Project	IEEE 802.16 Broadband Wireless Access Working Group < <a href="http://ieee802.org/16">http://ieee802.org/16</a> >	
Title	A Generic Packet Convergence Sublayer (GPCS) for Supporting Multiple Protocols over 802.16 Air Interface	
Date Submitted	2005-11-16	
Source(s)	Lei Wang, Brian Petry, Yair Bourlas, Kenneth Stanwood, Cygnus Communications Inc.  Phillip Barber, Huawei	Voice: 760-448-4168 Fax: 760-448-1989 <a href="mailto:lwang@cygnuscom.com">lwang@cygnuscom.com</a> <a href="mailto:bpetry@cygnuscom.com">bpetry@cygnuscom.com</a> <a href="mailto:ybourlas@cygnuscom.com">ybourlas@cygnuscom.com</a> <a href="mailto:kstanwood@cygnuscom.com">kstanwood@cygnuscom.com</a> <a href="mailto:pbarber@broadbandmobiletech.com">pbarber@broadbandmobiletech.com</a>
Re:	This is a follow-up contribution on the proposal of a generic packet convergence sublayer.	
Abstract	<p>As requested by 802.16g during the comments resolution discussions in session #39, we are submitting a follow-up contribution on our Generic Packet Convergence Sublayer proposal i.e., C802.16g-05/25, by presenting additional supporting materials and integrating suggestions and comments received from other members.</p> <p>We are c

Figure 17c: GPCS Layering Model

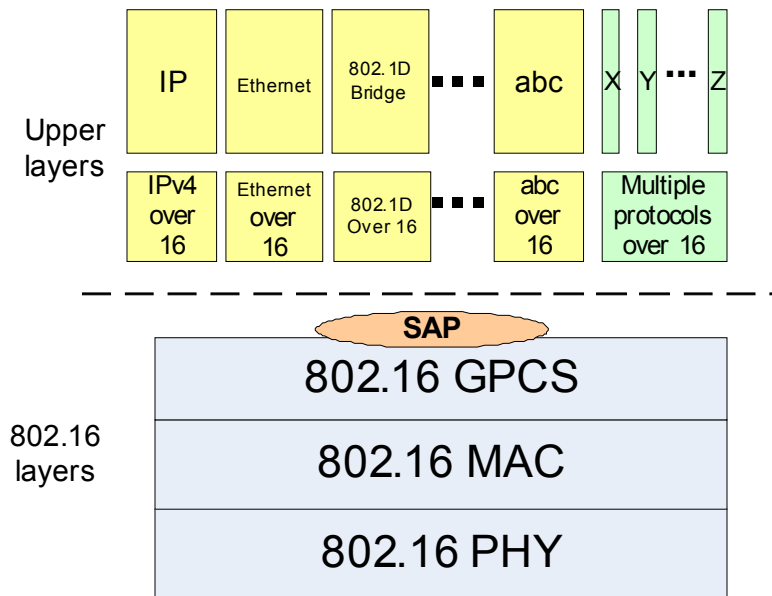
*[insert new subclause 5.2.8 and subsequent text below]*

#### 5.2.8 Generic Packet Convergence Sublayer (GPCS)

The Generic Packet CS (GPCS) is a upper layer protocol-independent packet convergence sublayer that supports multiple protocols over 802.16 air interface. It is defined as follows:

Figure 17d: GPCS SAP Parameters Model

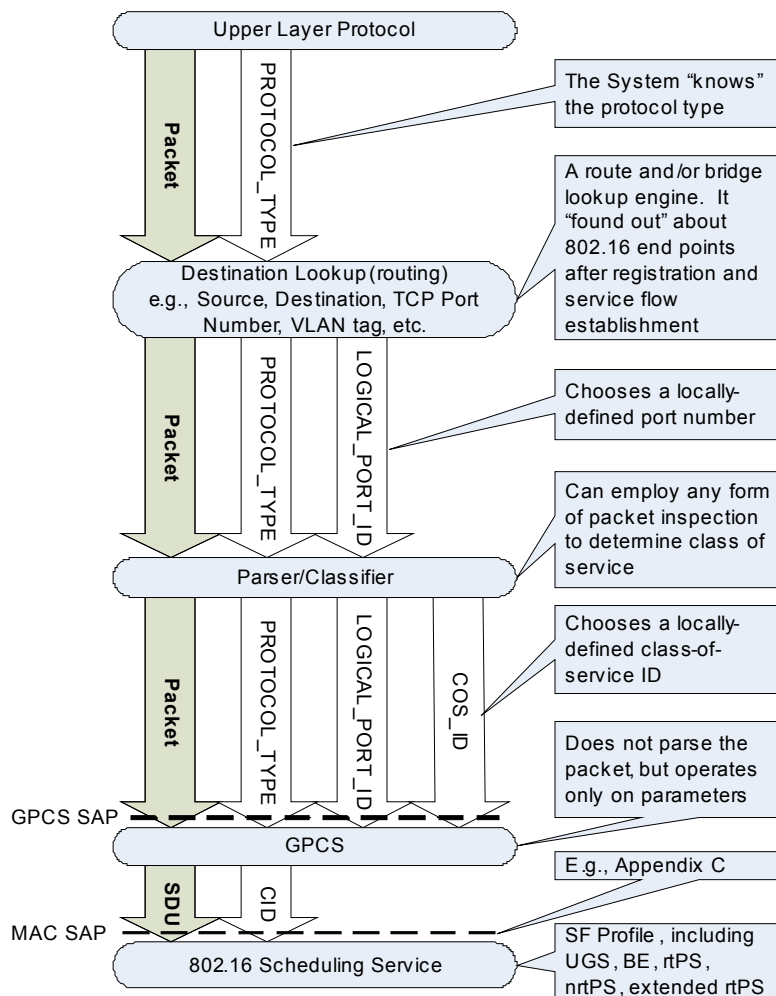
There are four GPCS SAP parameters: LOGICAL\_PORT\_ID, COS\_ID, PROTOCOL\_TYPE, and MULTI\_PROTOCOL\_ENABLE. Figure 17d depicts the GPCS SAP parameters model. It shows how the first three GPCS parameters, LOGICAL\_PORT\_ID, COS\_ID, and PROTOCOL\_TYPE, can be chosen in a system. The parameter, MULTI\_PROTOCOL\_ENABLE, is required for signaling whether or not the multiple protocol packets are transmitted on the same CID.
